# Upper Broadway Advocates

**Subject: PLN20141, ER19003 - - 5212 Broadway**

# CCA Site DEIR/PDP Design Critique

### Sketch Study

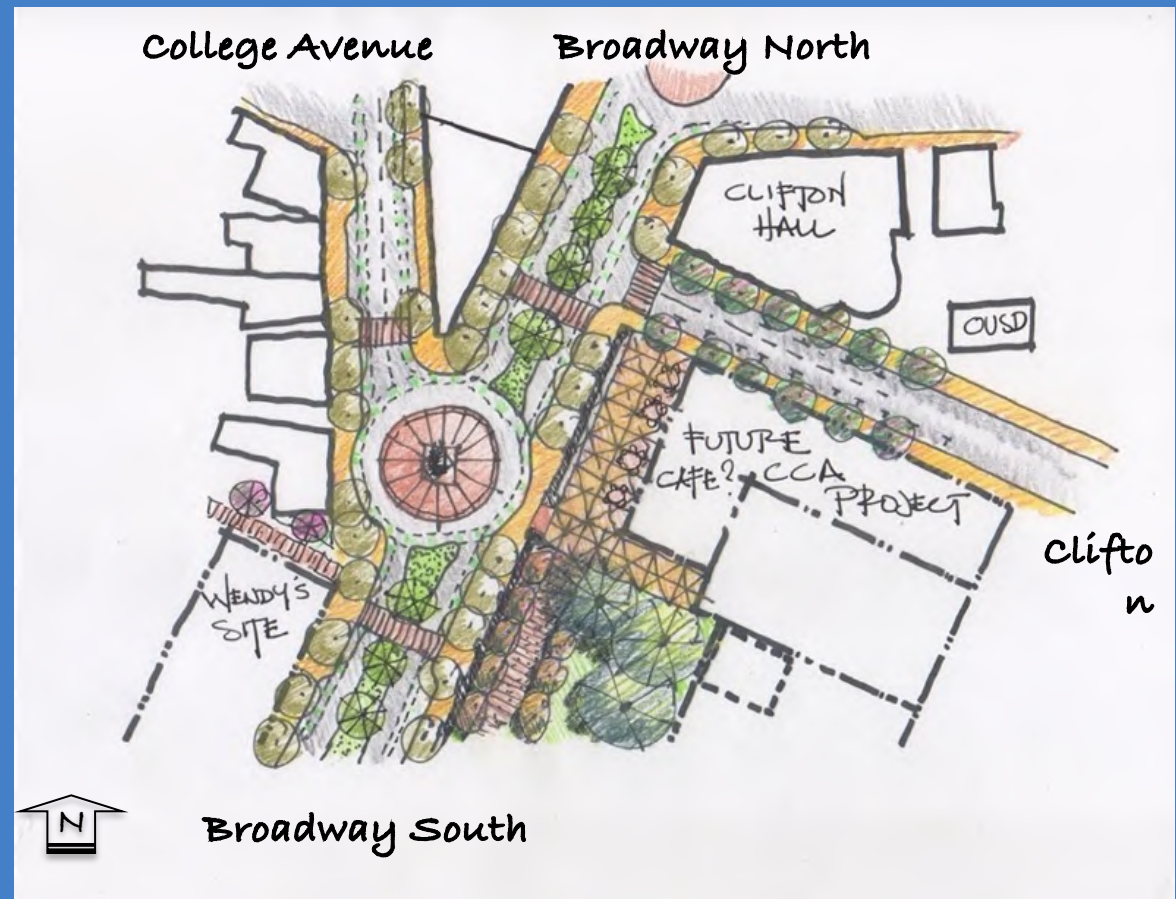
- 120' Diameter
- Transition from 1 to 2 Lanes

### Sketch Study

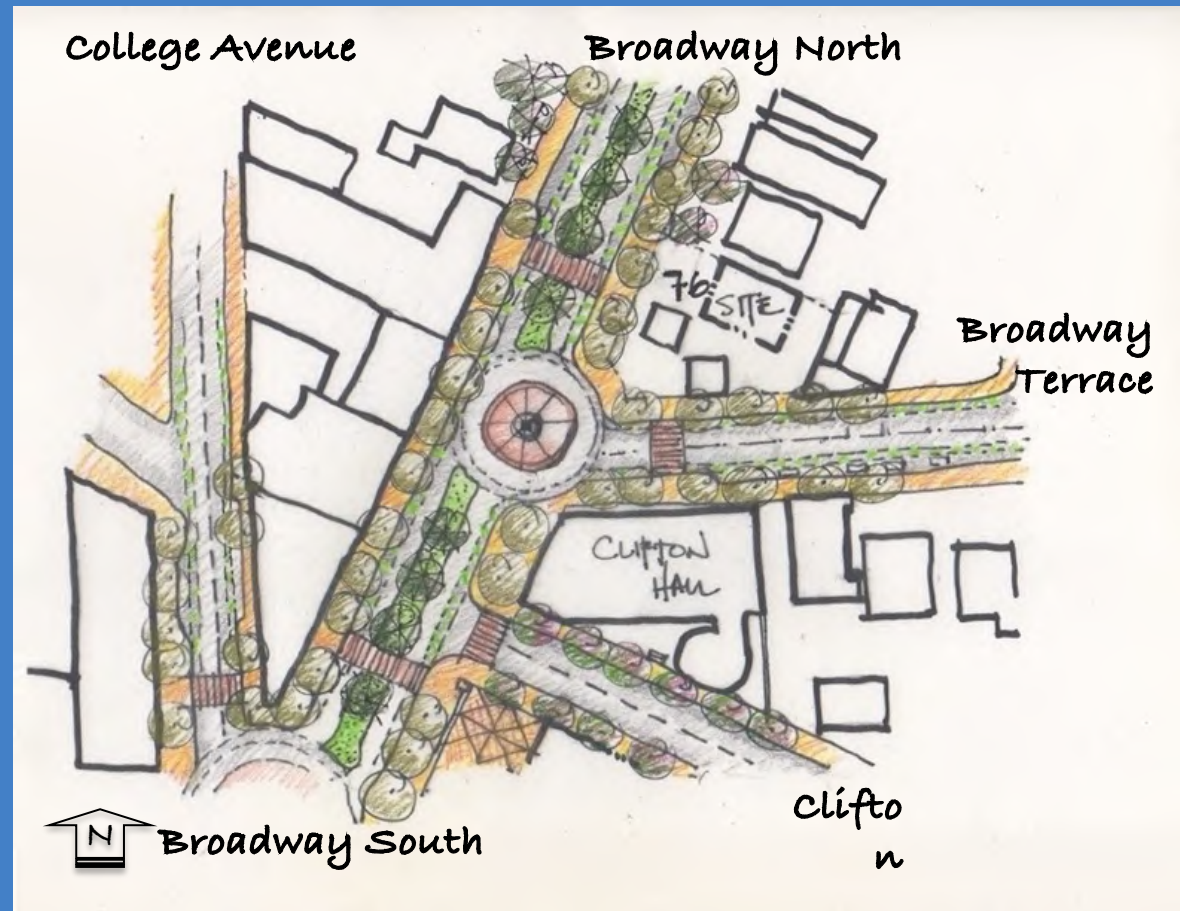
- 90' Diameter
- 1 Lane

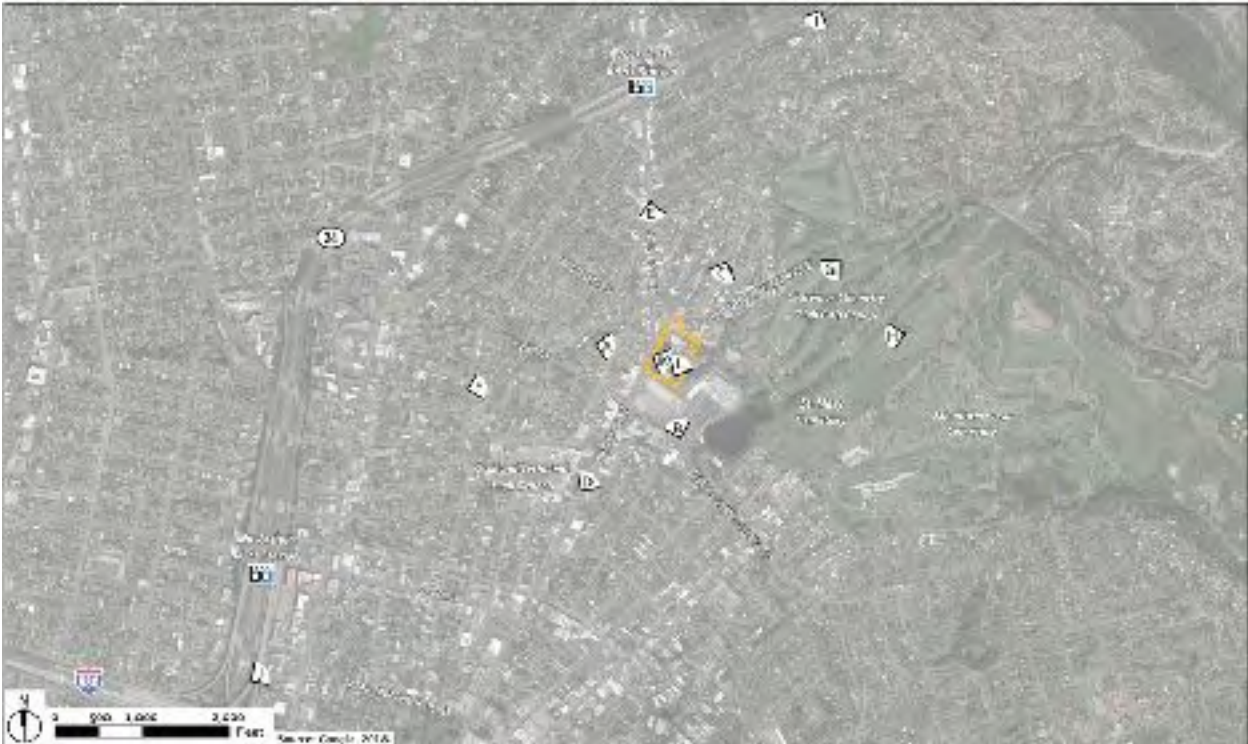
**Another possible viewpoint from Pleasant Valley.** No banks in the foreground and a clear view of the project.
